## Forest Protection Campaign

These supplemental comments on the proposed Kings River Project (“KRP” or “Project”) Final Environmental Impact Statement (“FEIS”) are submitted on behalf of the Sierra Nevada Forest Protection Campaign and the Sierra Club. (collectively, the "Campaign"). The Campaign previously provided scoping comments on this Project on or about February 2, 2005 and comments on the draft environmental impact statement (DEIS) on or about March 28, 2006.

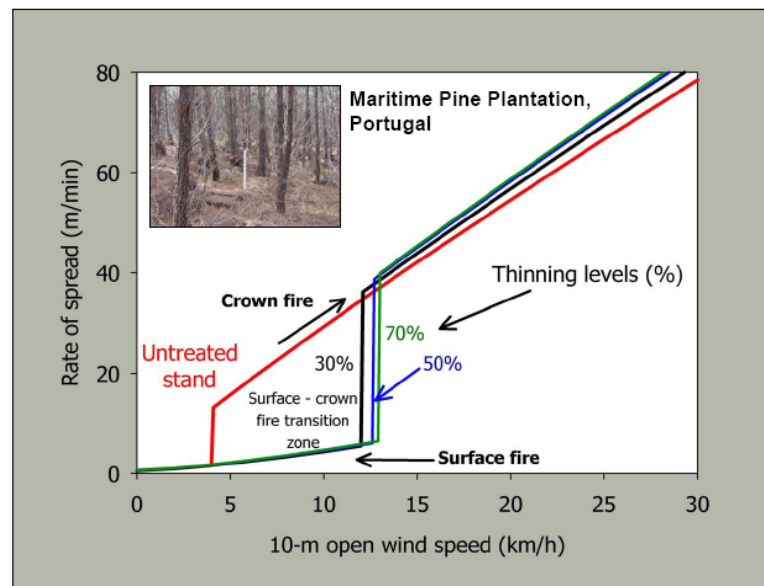
“The Fire and Fuels Analysis States the Desired Condition as Unrealistically Extreme  
The stated desired condition in WUI is extraordinarily and unrealistic. Table 2, entitled "Fire behavior - desired condition" of the Fire and Fuels Analysis displays post-treatment fire behavior, with a torching index of 167 mph and a crowning index of 10.7 to 441 mph. This means that the goal of the treatment is to create a stand that would need 167 mph winds to start crown fires and up to 441 mph for fire to spread in the crowns. The desired conditions for all threat zones are to have a crown index of 200 mph under 90<sup>th</sup> percentile weather conditions. Table 4 entitled "Fire behavior variables, proposed action with severe fire" indicates some location in each treatment area be treated to such a drastic extent that hurricane-force winds could not start or spread crown fires. The desired condition results in a forest treated to such an extreme that the treatment could cause undue damage to the environment.

The crowning index is a measurement of the wind speed necessary to spread fire in the forest canopy. A crowning index of 271 indicates winds would need to be 271 miles per hour before crown fires would be maintained. This is a windspeed probably never experienced in the KRP, a wind four times faster than the definition of hurricane-level winds. Rothermel (1991) records 20-ft windspeeds for seven well-known wind-driven crown fires. The fastest windspeeds (for the Sundance Fire) was 45 miles per hour. The Sundance Fire was a famous crown fire that was among the most severe and largest fires in US history.
